HORNSEY TOWN HALL

S96

DESIGN DOCUMENT

20th February 2026

Planning application:
PA2007 - Town Hall Proposed Plan Roof
(East)

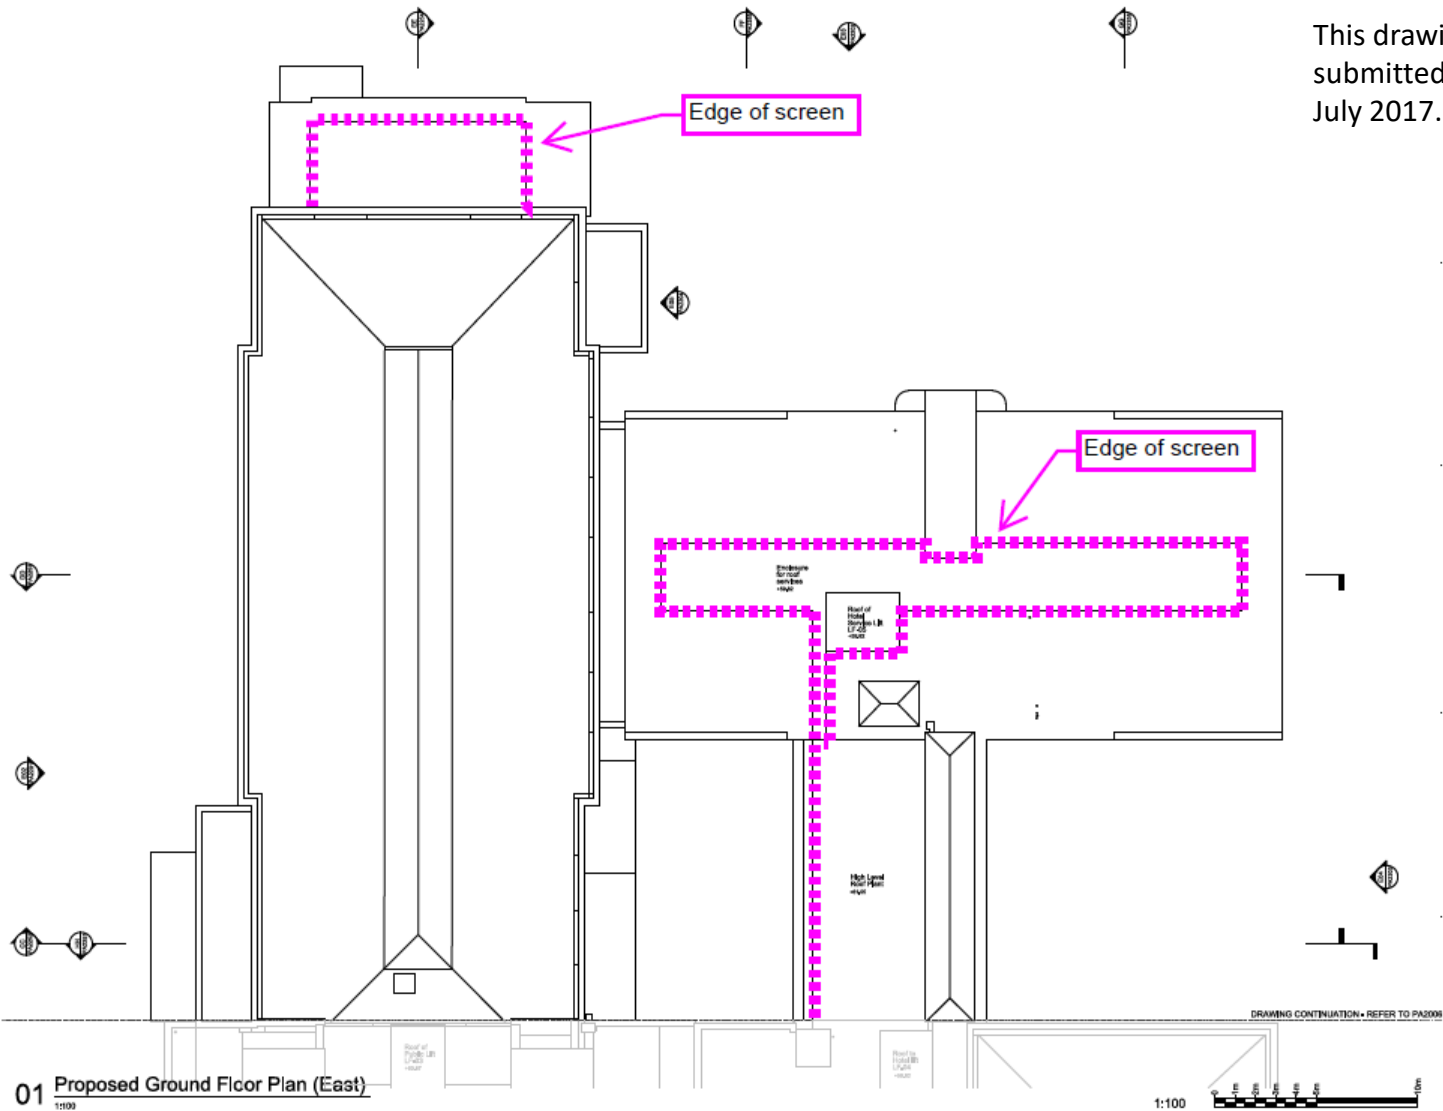
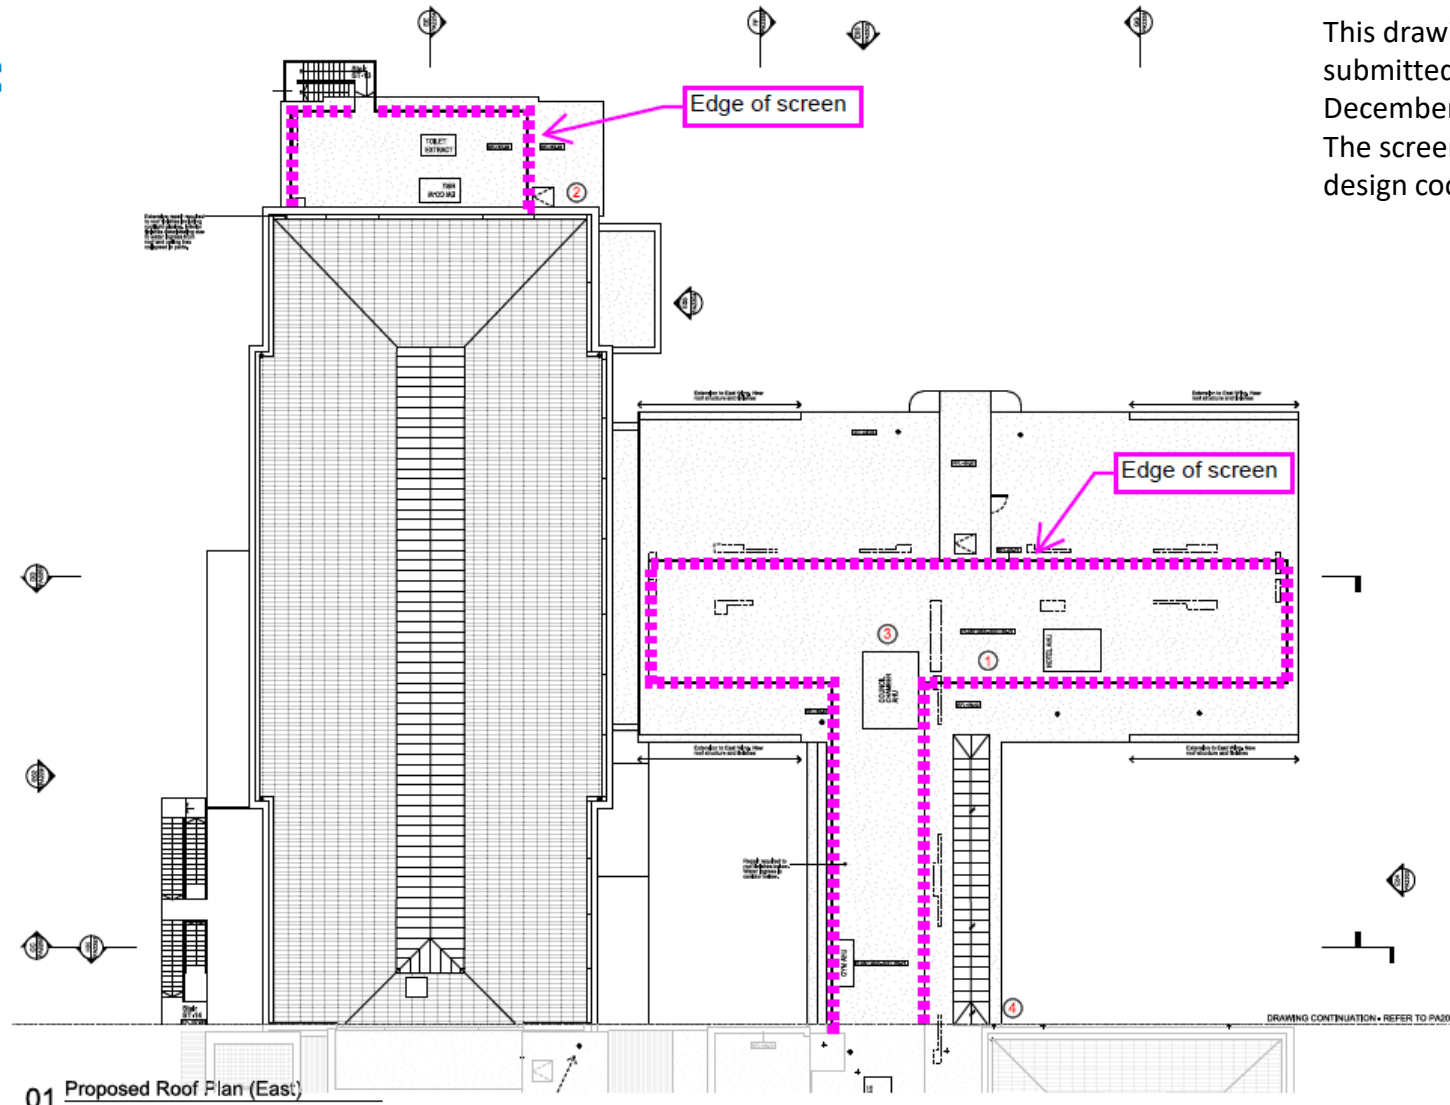
1. Following design development with the services engineers, further detail has been added to the roof plan indicating allocation of plant spaces and service routes. The consented scheme indicated an allocation of plant space on the East Wing and Link Building. On the East Wing, the extent of the area and height of the plant has to increase to suit the Town Hall's servicing requirements. A screen is designed to prevent plant from being visible from the public realm below. The plant is not visible from the Broadway. Refer to the following pages for sketch views.

2. To meet current fire regulations, automated opening vents (AOVs) will have to be introduced above stairwells and atriums. Where these vents occur in rooflights, an existing glazing section will be replaced with a like-for-like glazing section. These vents connect to the building's fire alarm system and will open in the case of a fire for smoke clearance. Similarly, AOVs are introduced in the flat roof sections of stairwells. These vents will appear like skylights when seen from within the stairwell. These automatically open when activated by the fire alarm.

3. The omission of the lifts as explained in earlier pages results in the omission of lift overruns. This helps preserve as much as possible of the original roofscape of the Town Hall.

4. The rooflight shown on this plan is one of two described on the earlier page. There is suspected Asbestos on this rooflight which is also in a deteriorated state due to lack of maintenance. The corridor below has severe damp issues and several leaks have appeared in recent months. This rooflight will be replaced with a new rooflight with its metal framing and glazing details matching the existing like-for-like.

PA2007 - Town Hall Proposed Plan Roof (East)

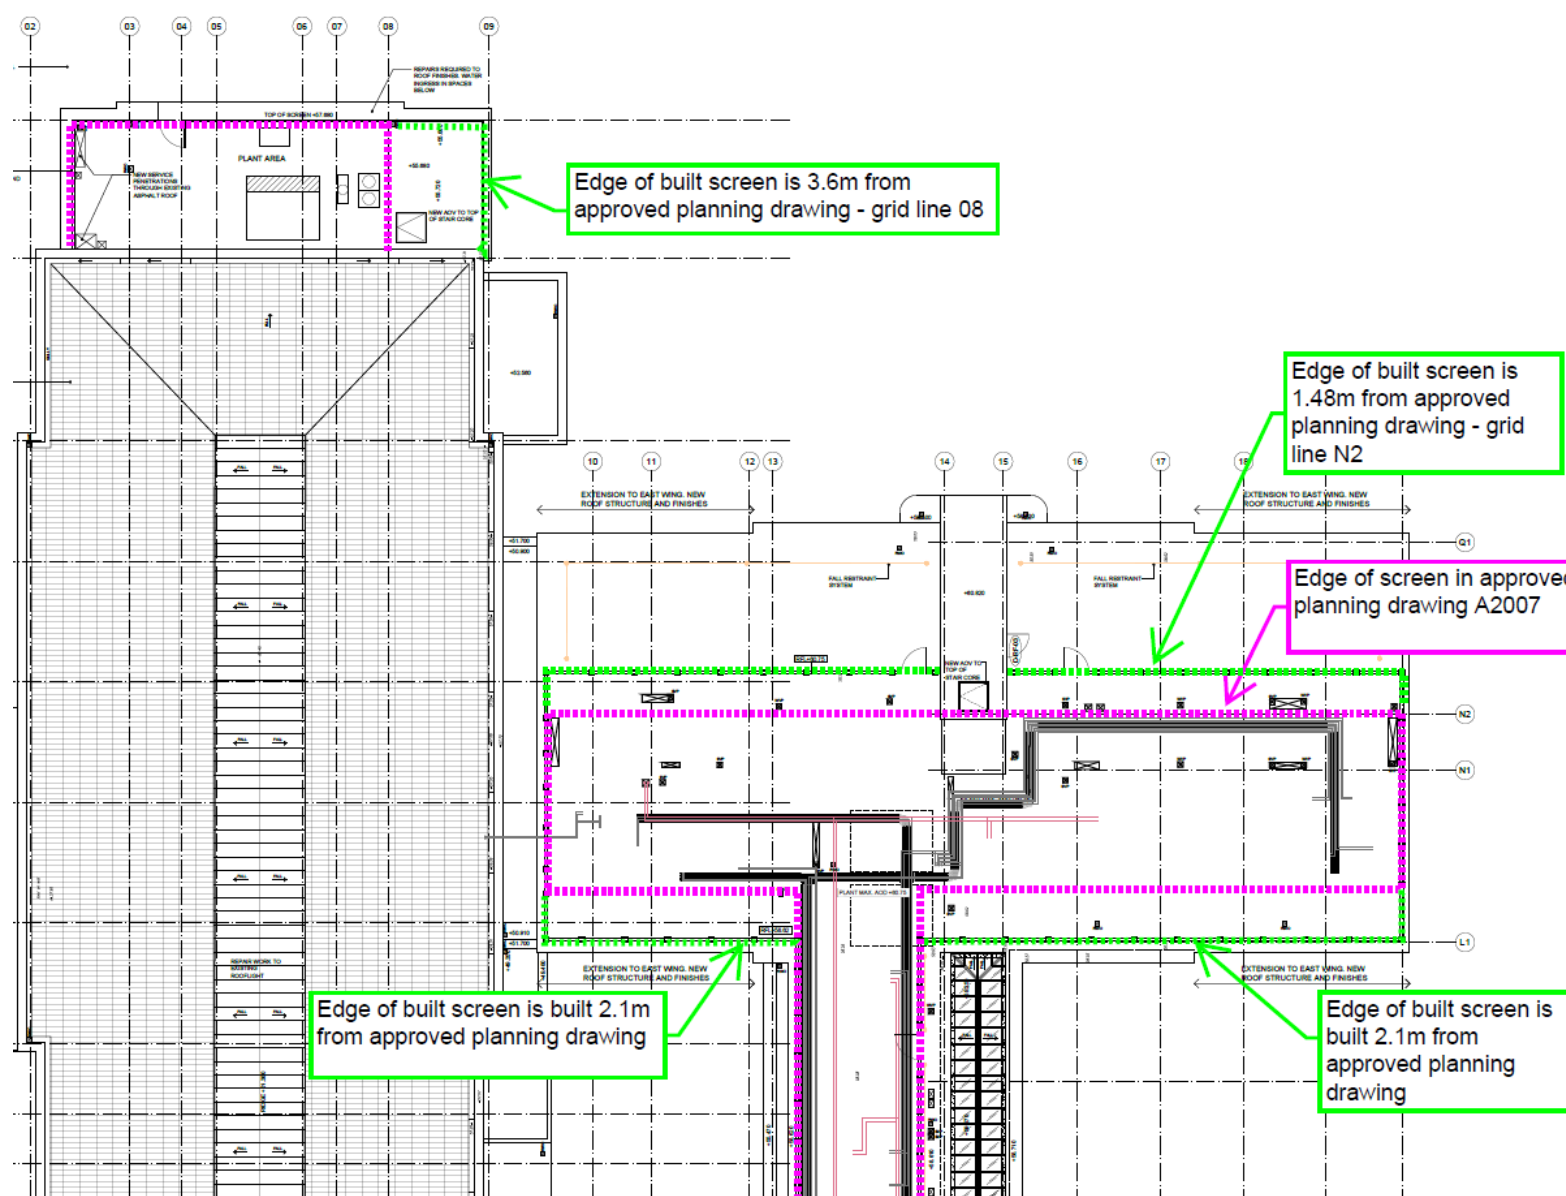
This drawing shows the edge of the screen as submitted as part of a S96 application in December 2018.

The screen was extended outwards following design coordination with MEP consultants.

S96 Application drawing: PA2202 - Town Hall Proposed Elevation 03 (East)

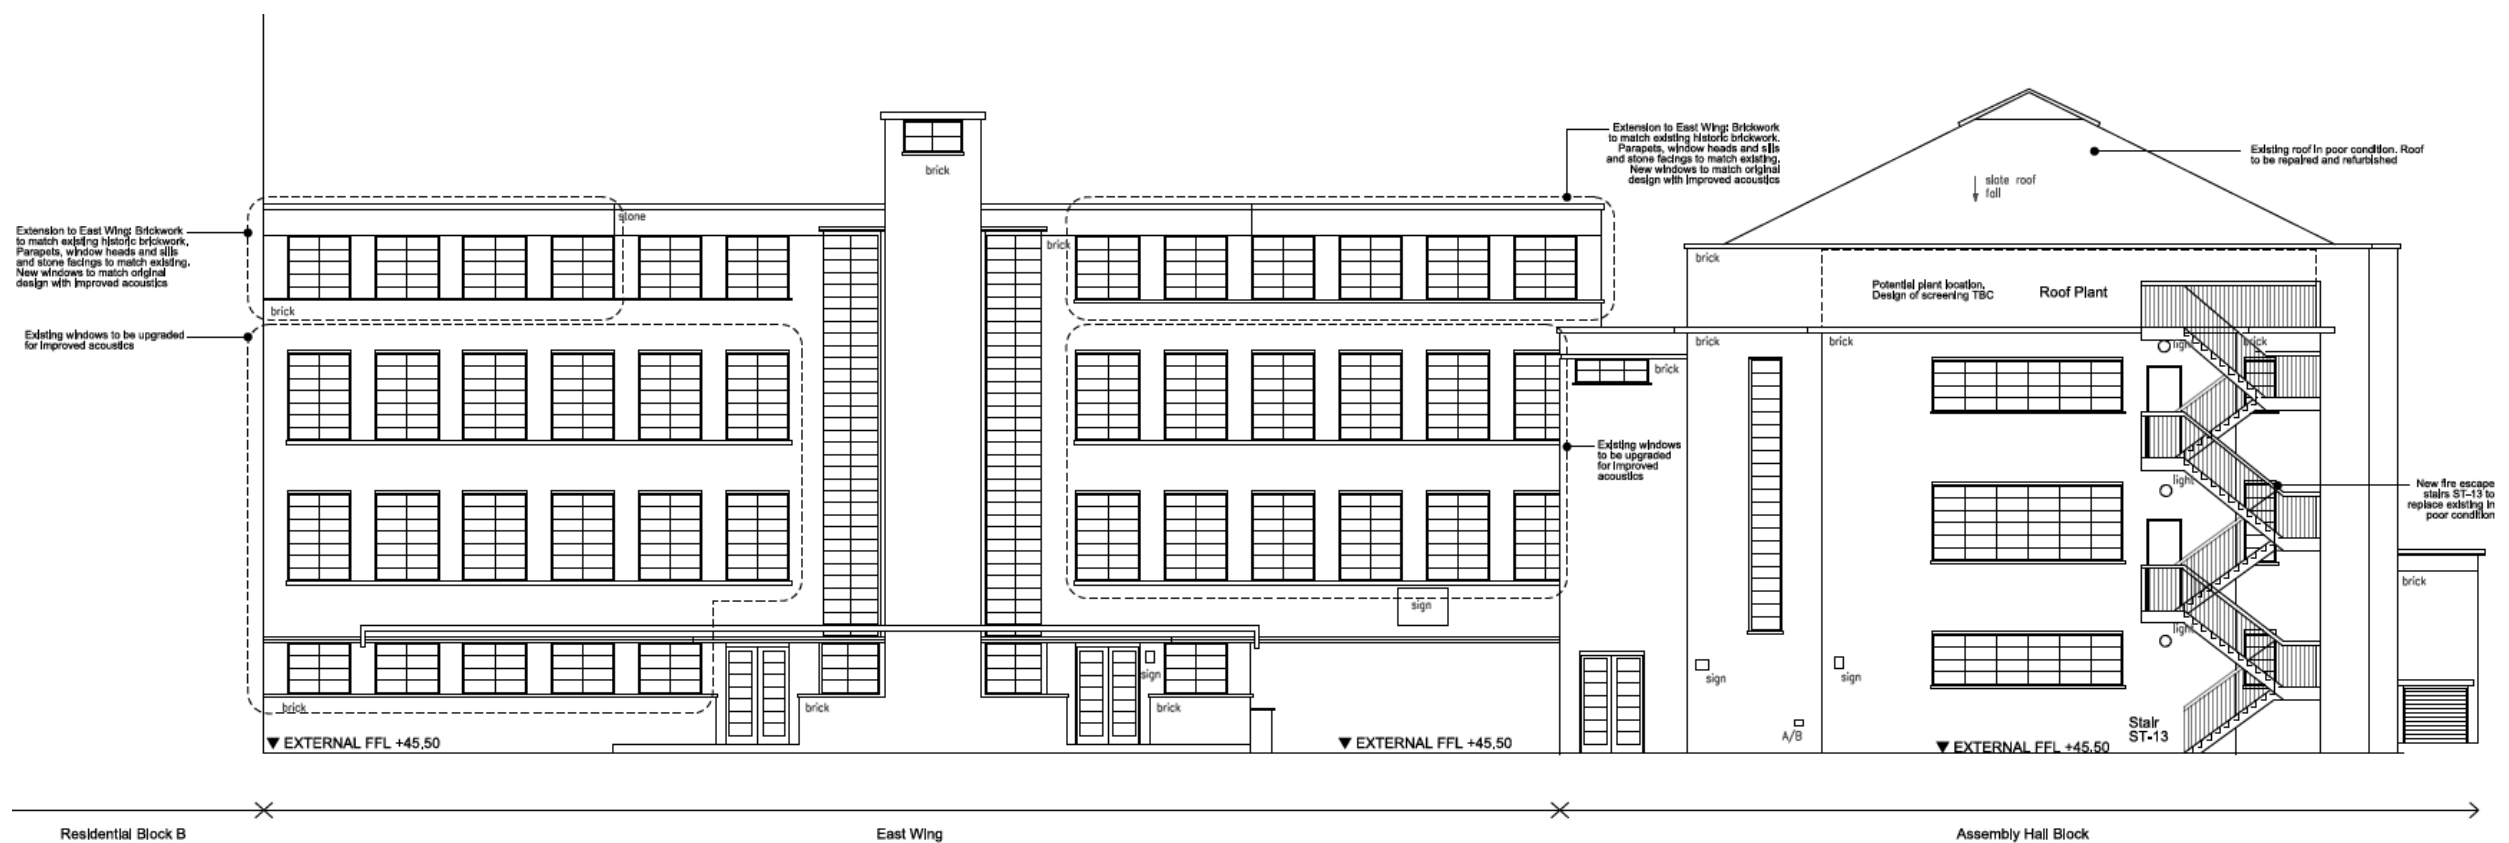
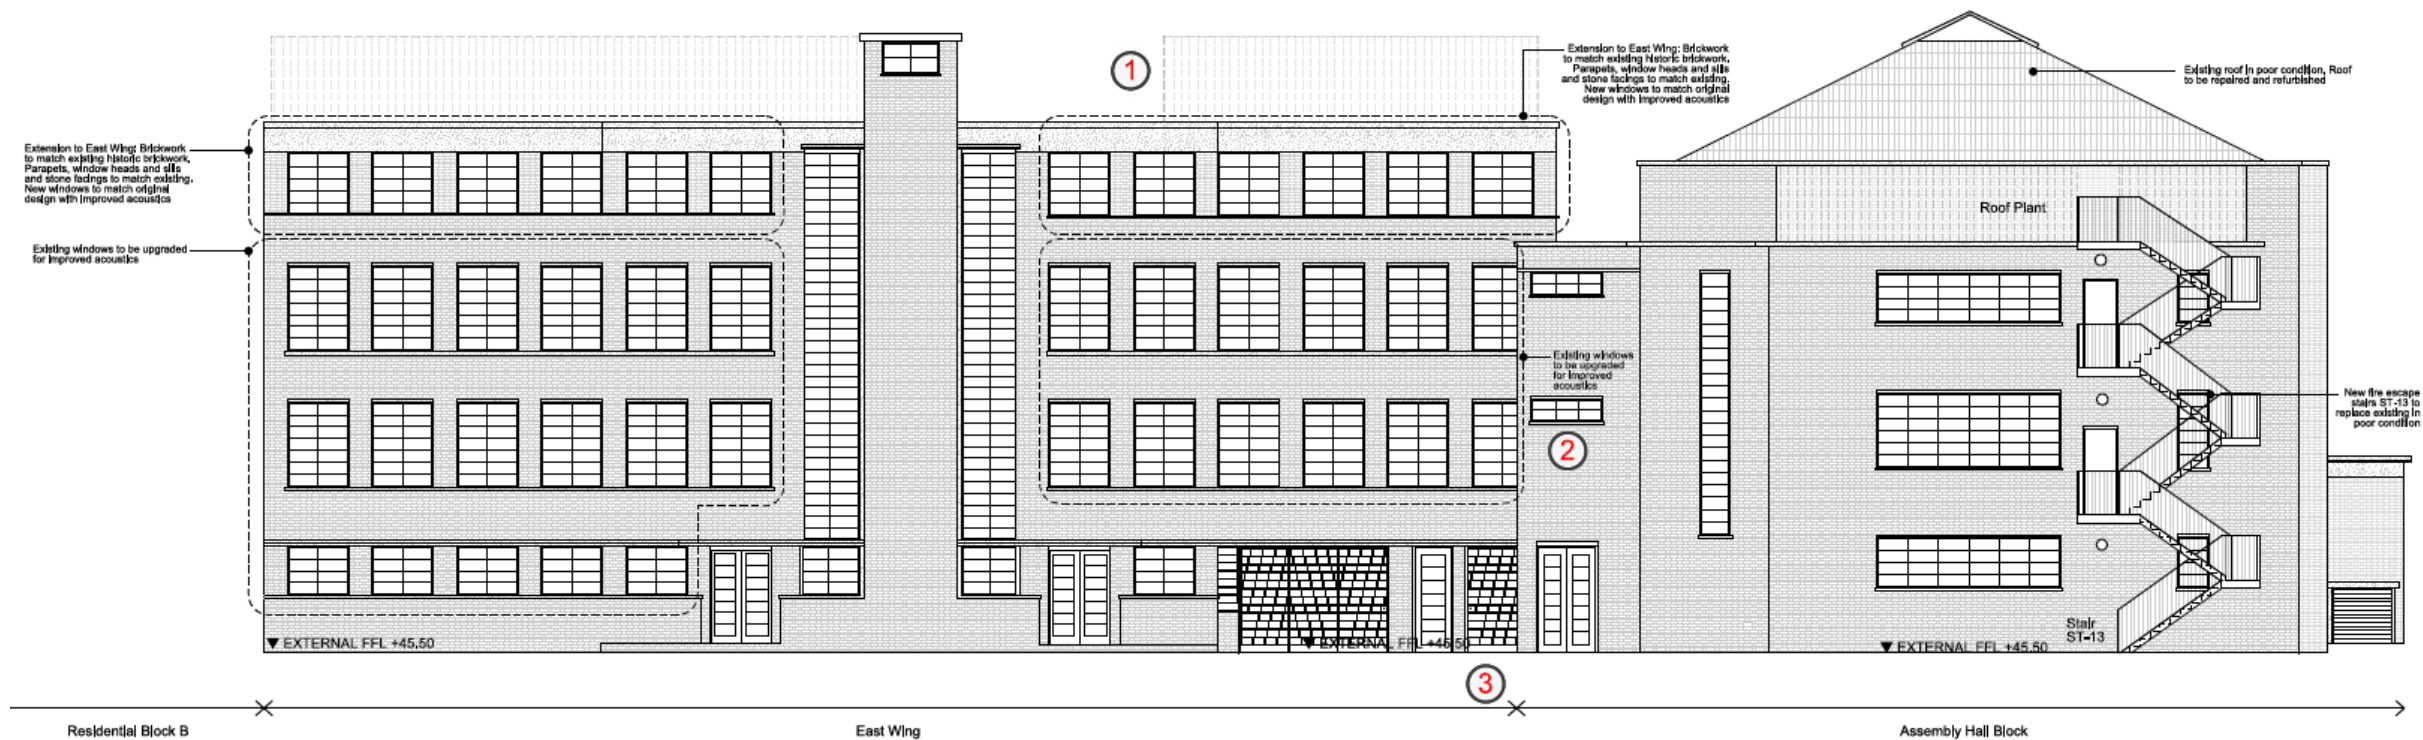
The drawing shows the edge of the screen as submitted in S96 in December 2018.
The screen was extended following design coordination with MEP consultants.
